GTS Newsletter

2009/02E

Machine	TASKI swingo XP
Subassembly	Upper Part

New tank cover TASKI swingo XP

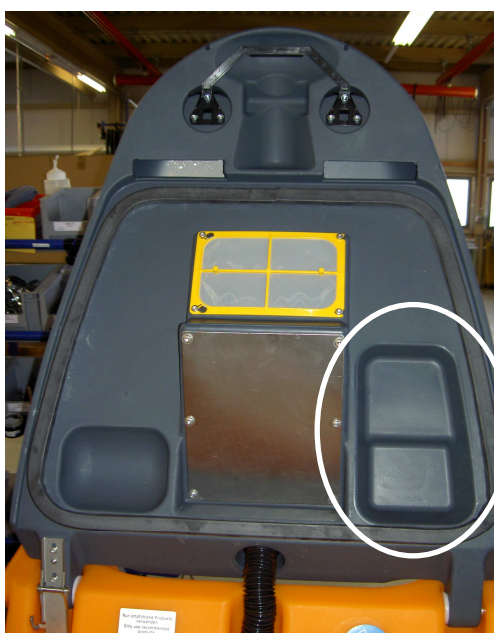
Due to increased feedbacks from the field that the fresh water suction hose in the area of the flex tank support (metal frame) got damaged, we have adjusted the shape of the tank cover (white marking). As a result of this modification the hose has a wider space for movements, which is preventing injuries by squeezing and rubbing on the metal frame.

The new tank cover is reverse compatible and can be ordered under the existing material number 4124371 (18600-89)

as of machine number 2981
